IREDELL COUNTY HEALTH DEPARTMENT

IMPROVEMENT PERMIT / AUTHORIZATION TO CONSTRUCT / OPERATION PERMIT / EXISTING SYSTEM

LOT 14 BELLS CROSSING SUBDIVISION

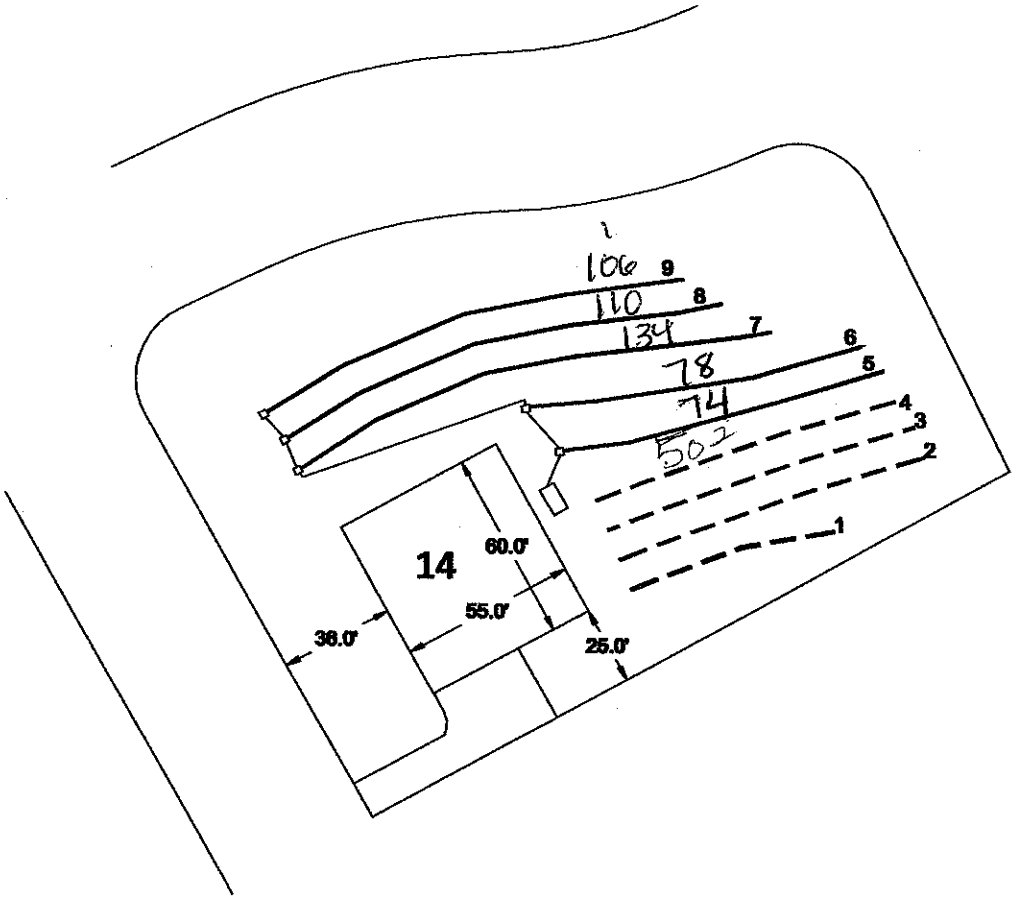
~~#~~ 36" TRENCH BOTTOM APPEARS TO BE OK BASED ON SOIL DESCRIPTIONS MAP 4-7-16

ALTERATIONS TO DRAINFIELD, SEE SITE PLAN

ONLY 500# REQUIRED FOR DRAINFIELD
